January 29, 2019

RE: TxDOT's Oak Hill Parkway Project Response to Bruce Melton January 25, 2019 letter

Growth-Traffic Workshop Meeting Documentation Form

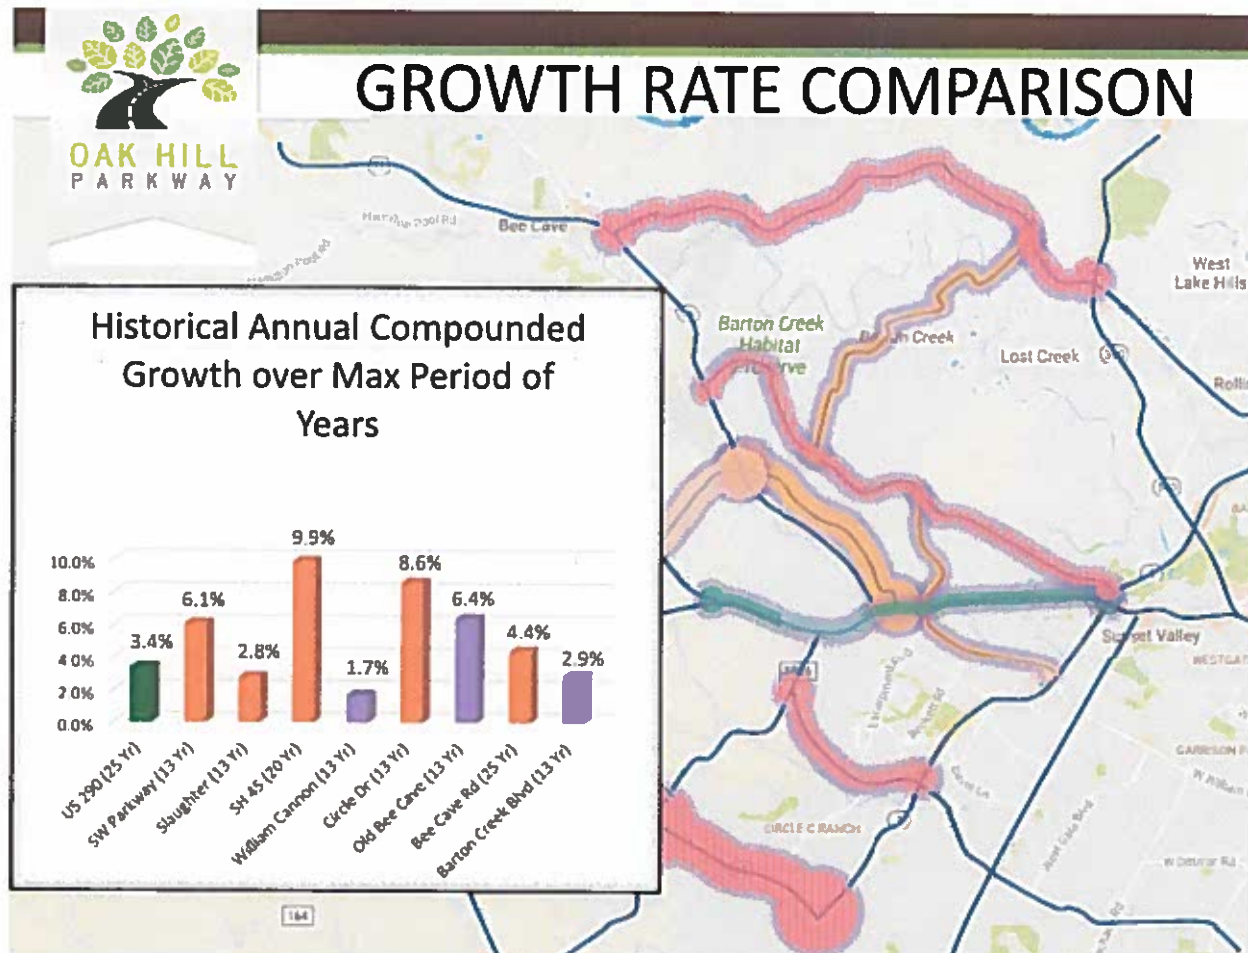
As shown on Page 2, the traffic projection rate proposed for US 290 (3.58% per year) is in line with the actual traffic growth rates experienced on some of the alternate routes like Southwest Parkway (6.2%), Circle Drive (8.6%) and Bee Cave Road (4.4%). These existing growth rates are considered relatively high.
